Town of Kittery Planning Board Meeting October 26, 2023

ITEM 1—283 US Route 1—Master Site Plan — Preliminary Review

STAFF COMMENTS

C-102

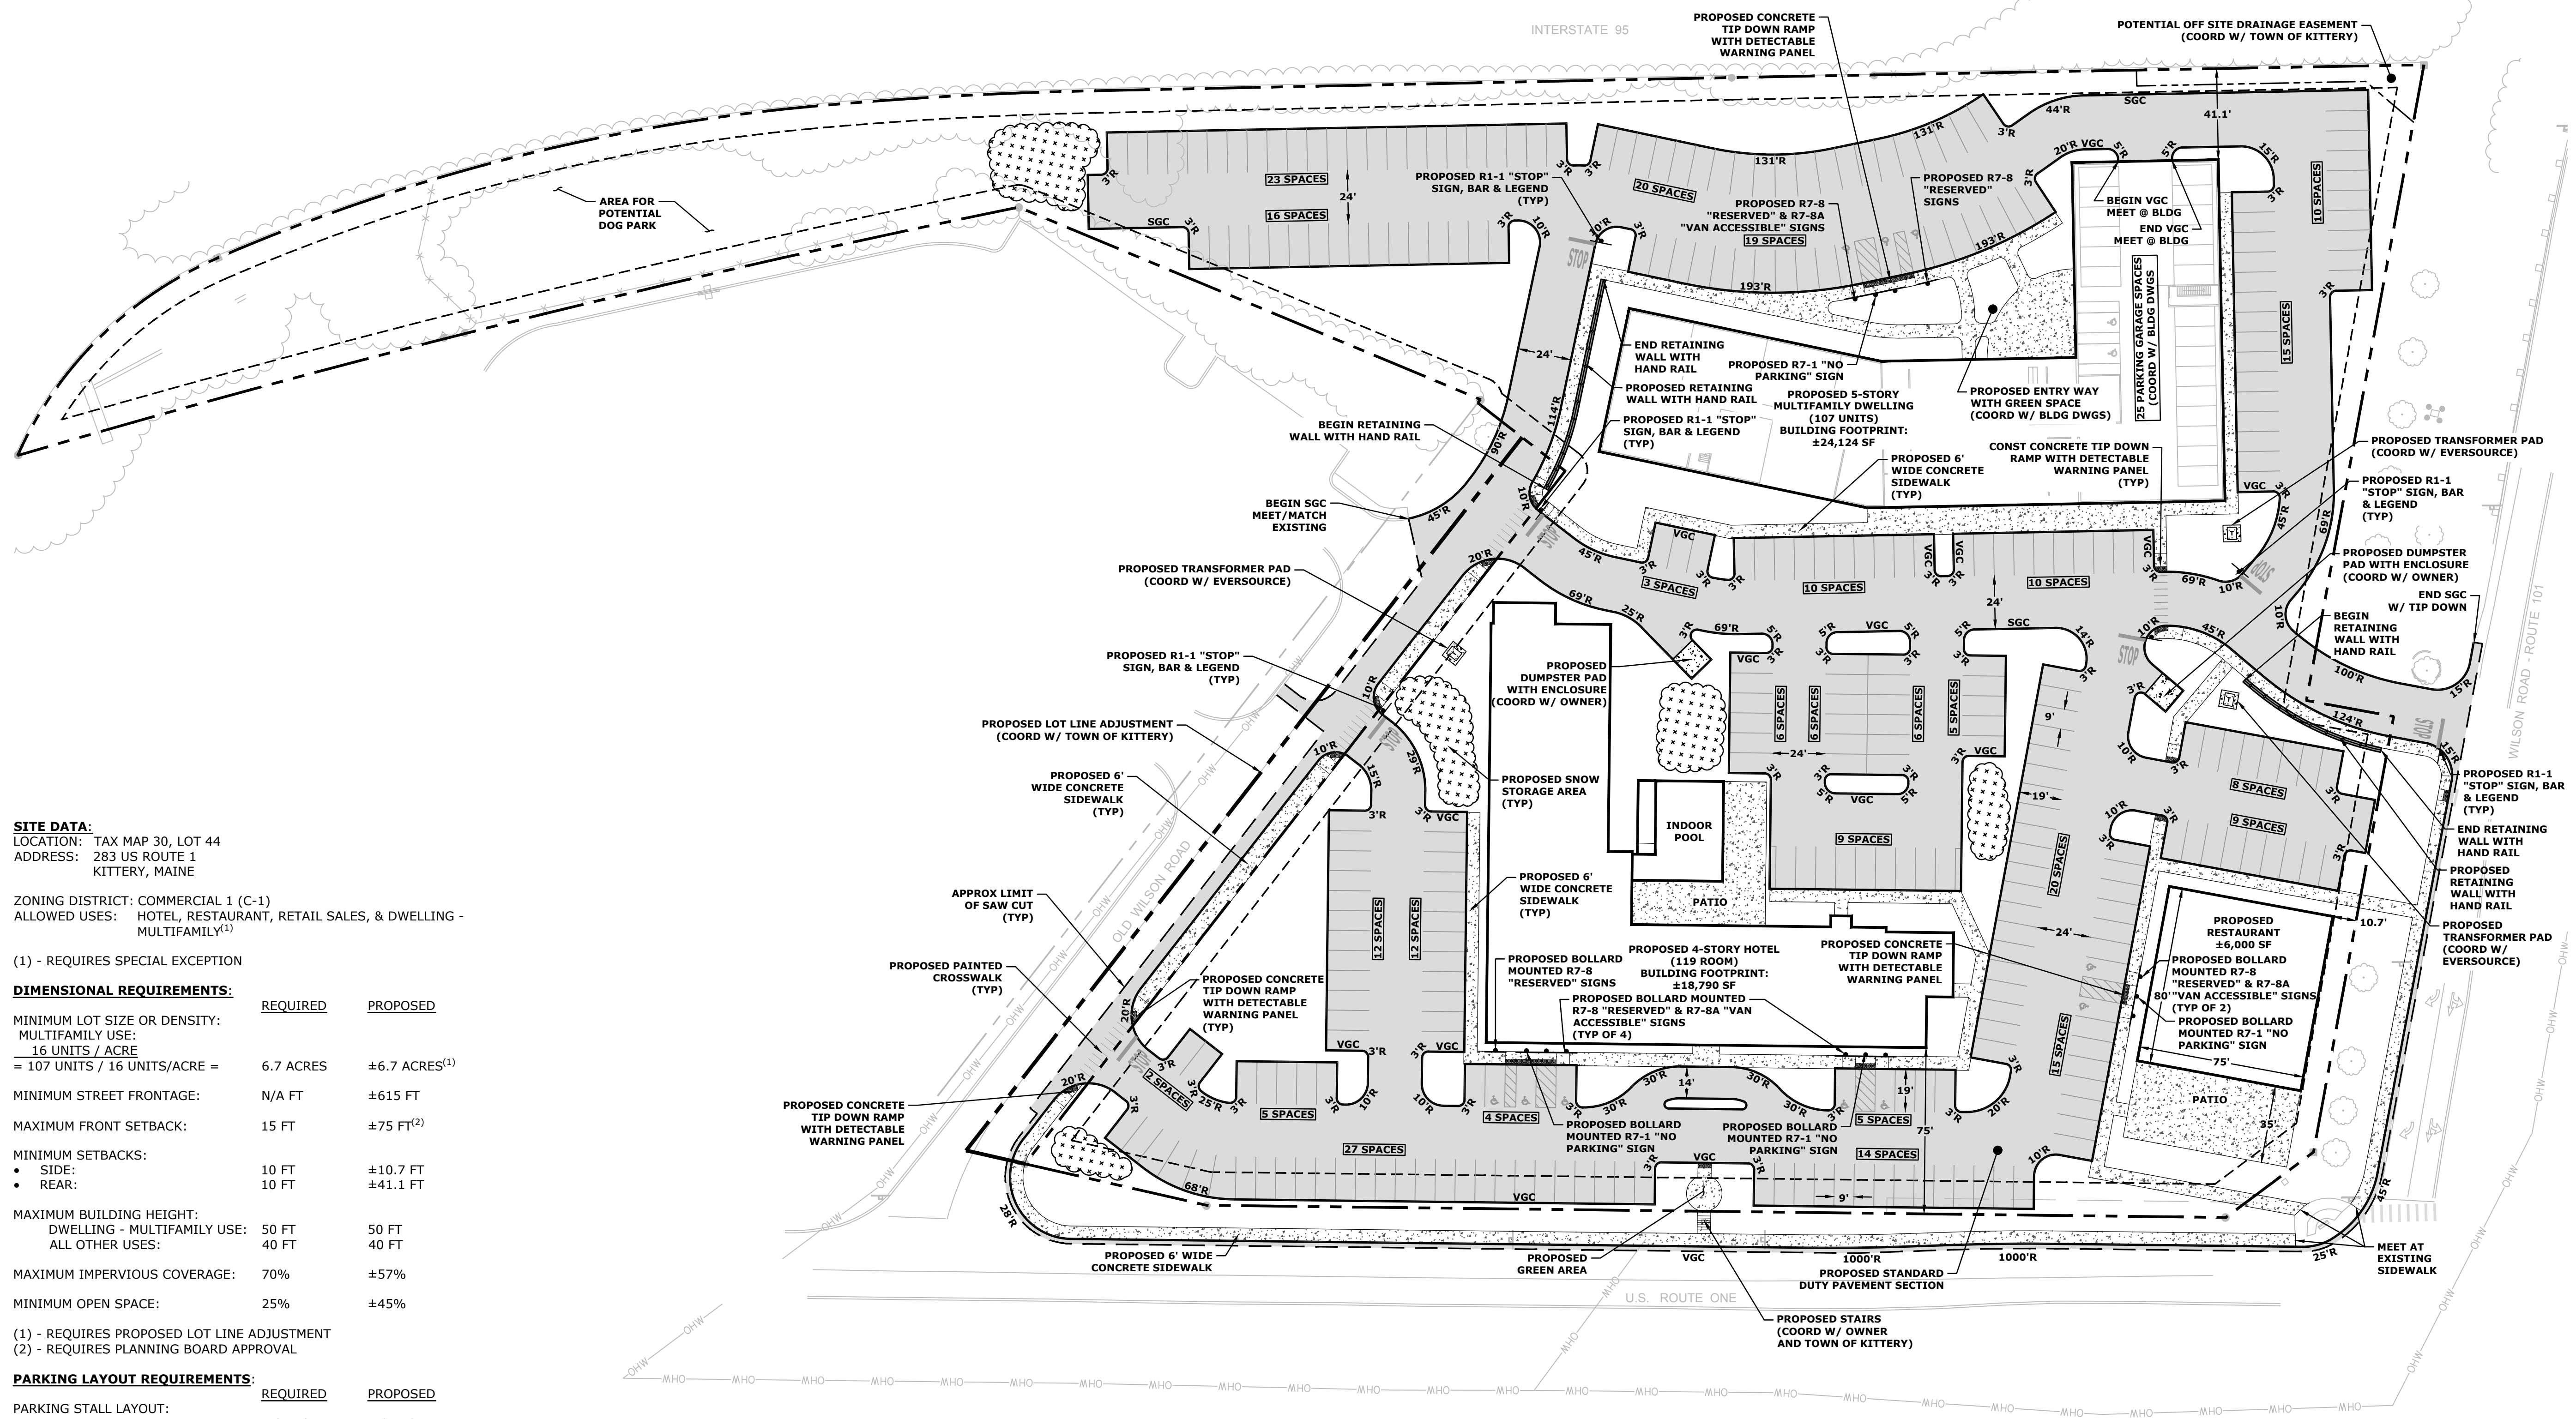
3. The site plan (sheet C-102) has proposed snow storage areas. Note 18 on this sheet details snow storage procedures.
4. The site plan does not show any canopy or overhanging area for the proposed hotel. If the hotel is providing one, this is considered a structure and must be included in building footprint calculations and meet NFPA standards.

5. The applicant was seeking a lot line adjustment on Old Wilson Road to get access from the Town to perform maintenance (shown on sheet C-102). Public Works does not believe a lot line adjustment is necessary, as maintenance responsibilities are already the burden of the private property owner.
